STERLING RANCH MDDP AMENDMENT NO. 2 & PRELIMINARY DRAINAGE REPORT FOR STERLING RANCH EAST PRELIMINARY PLAN NO. 1

CCES Responses

PCD Project No.
SKP-22-004 / SP-22-004

STERLING RANCH EAST PRELIMINARY PLAN NO. 1
Pre-Developed Surface Routing

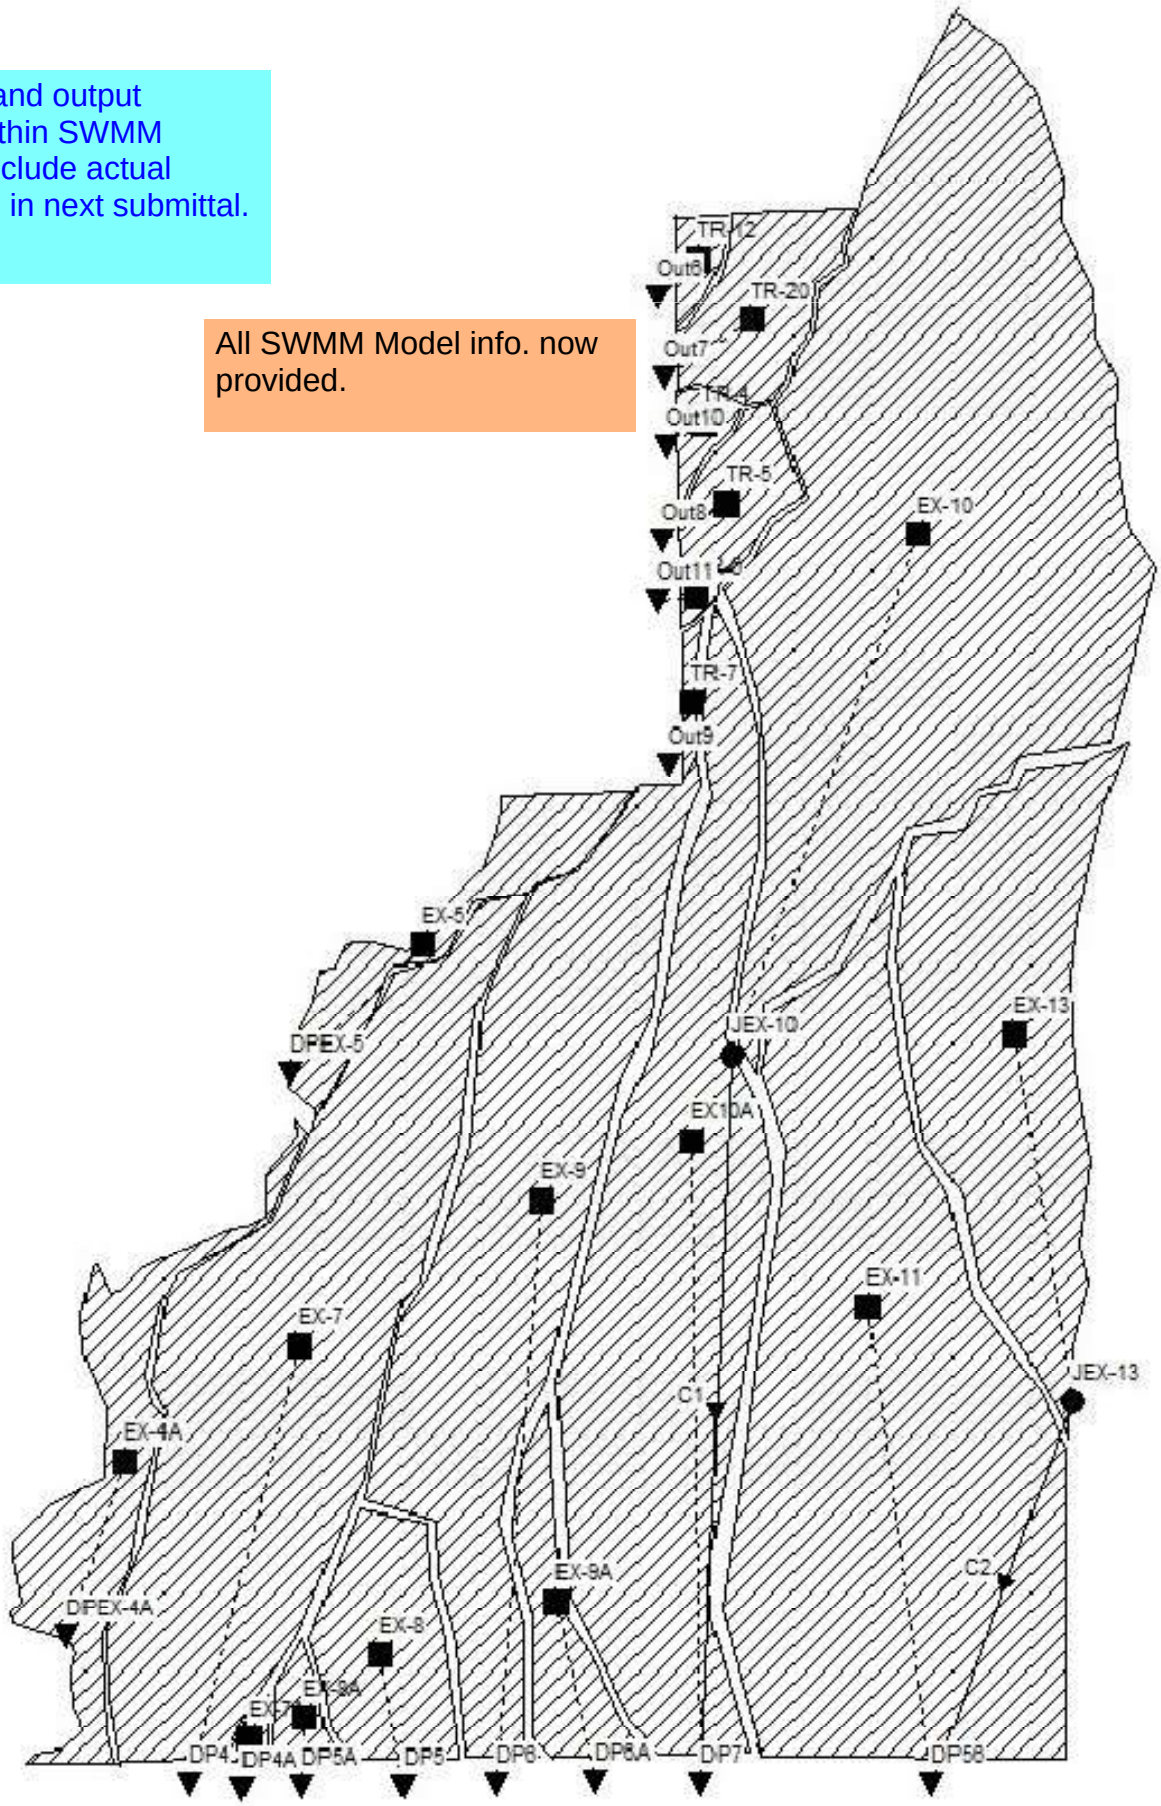
Include input and output information within SWMM model. Also include actual SWMM model in next submittal.

All SWMM Model info. now provided.

STERLING RANCH EAST PRELIMINARY PLAN NO. 1

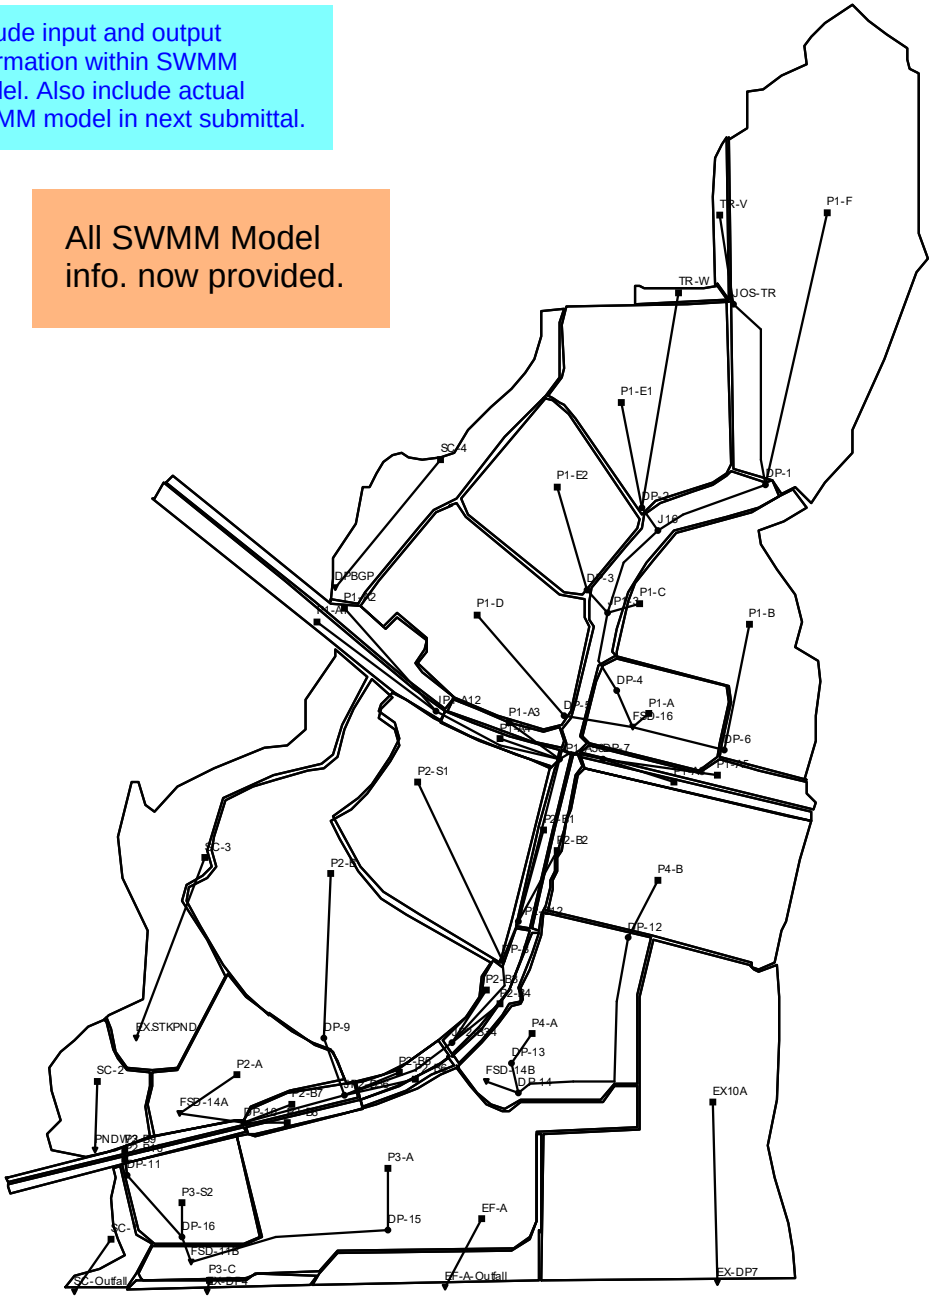
Include input and output information within SWMM model. Also include actual SWMM model in next submittal.

All SWMM Model info. now provided.

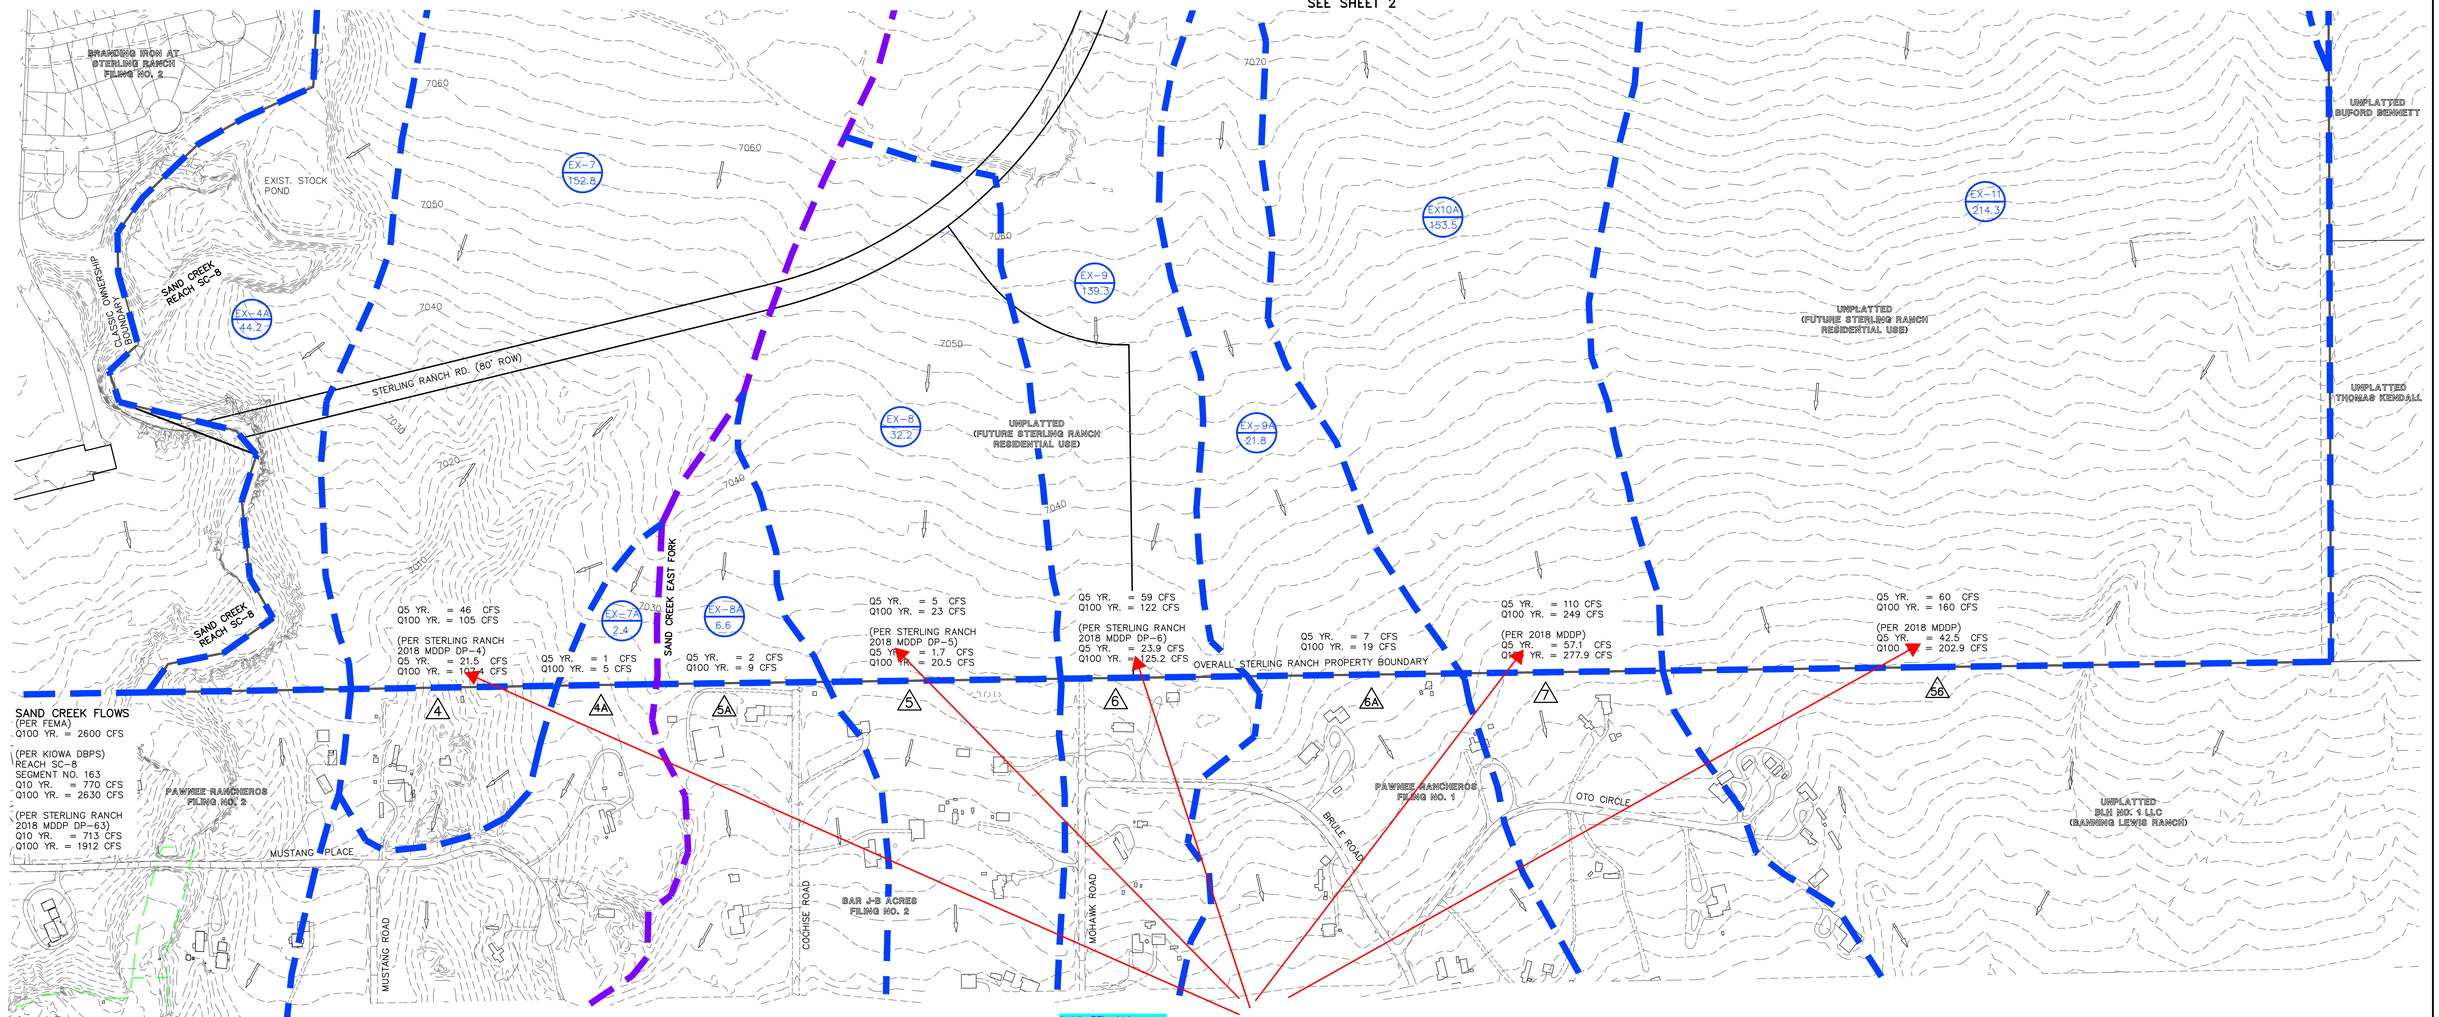
List the DP's which correspond to MDDP DP's

They are each listed above

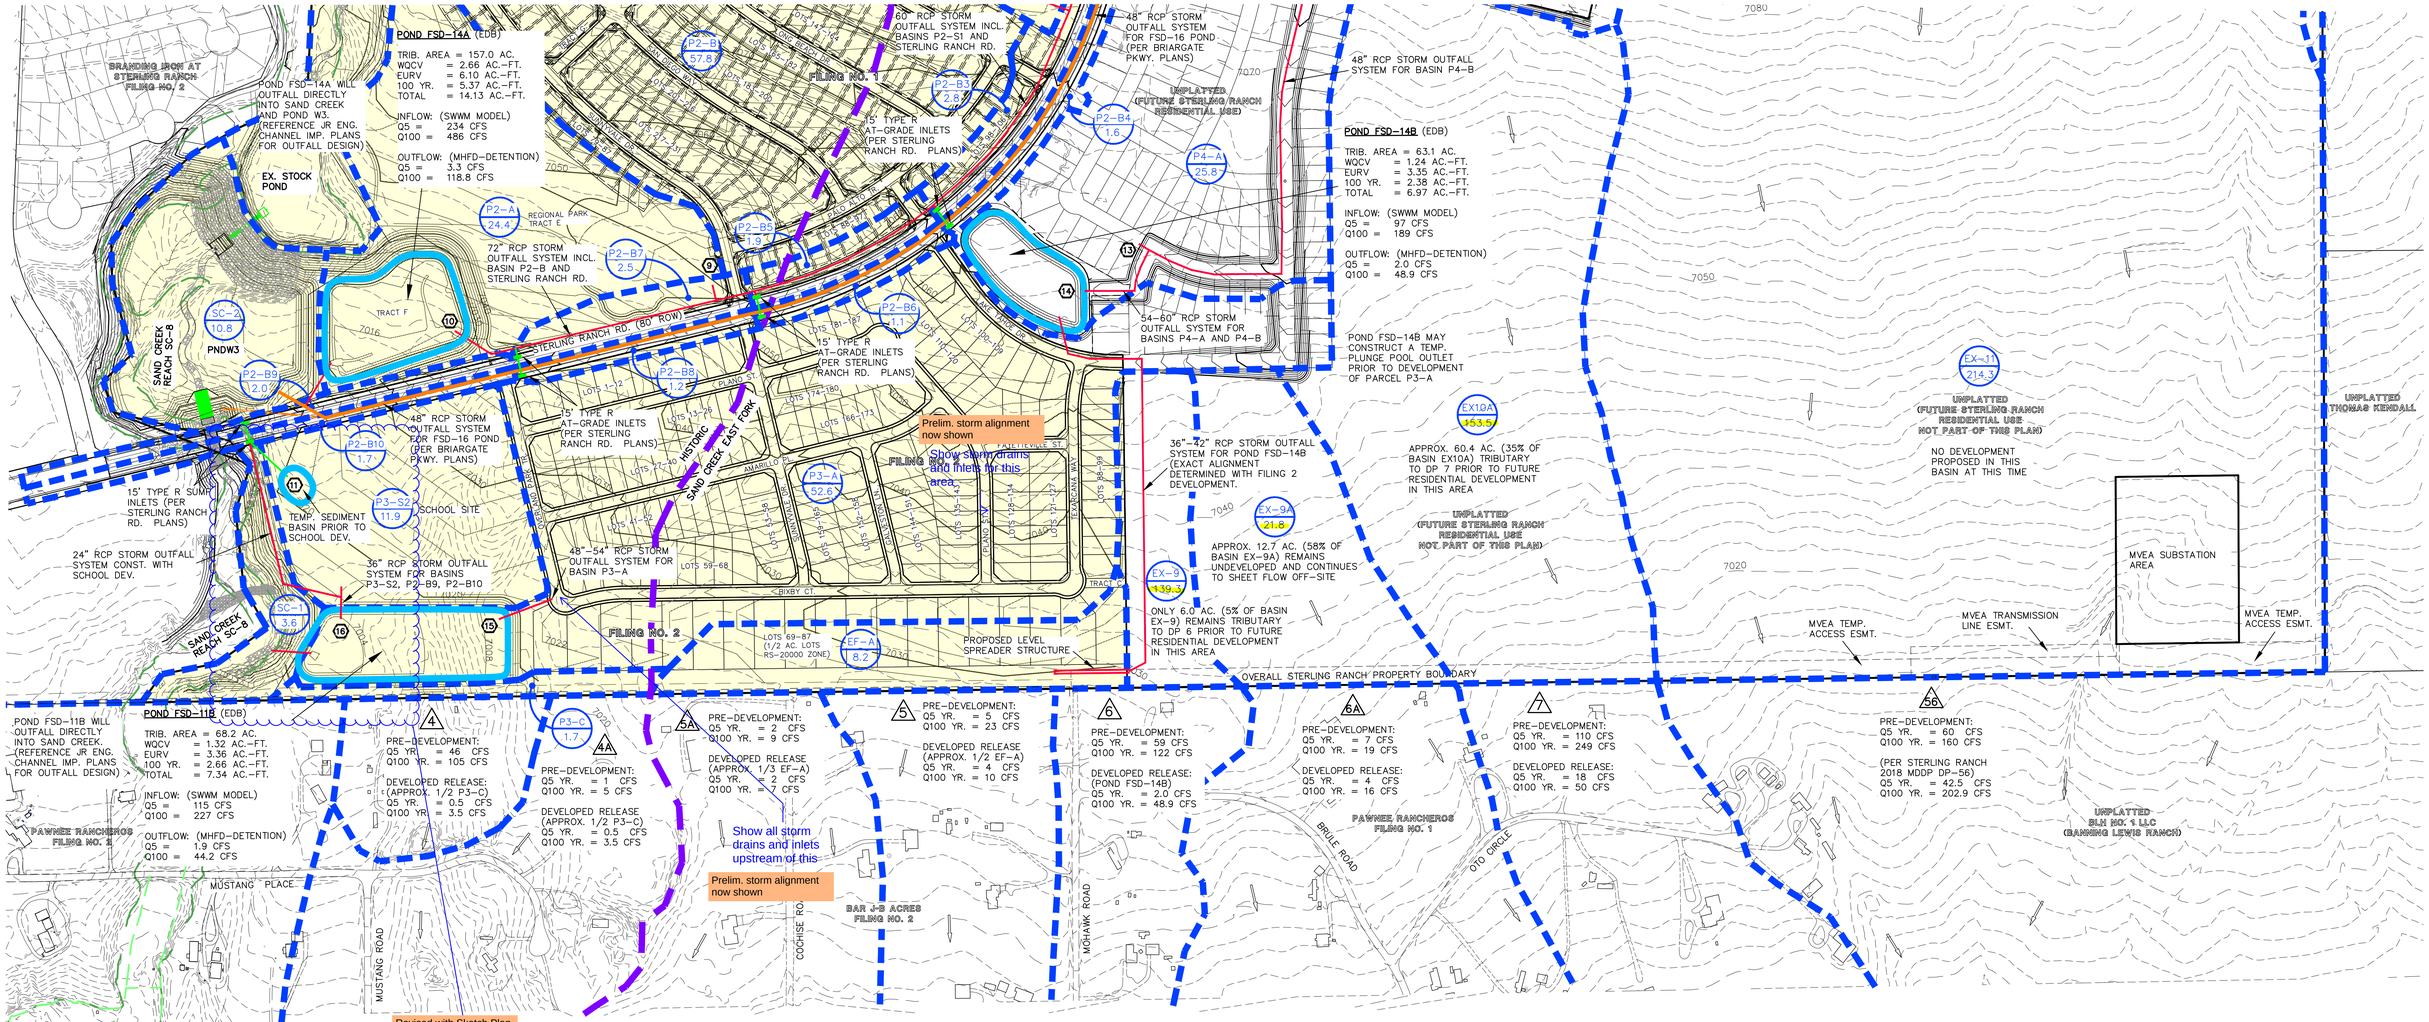
See comment memo

Revised with Sketch Plan comment. See revised narrative and map.
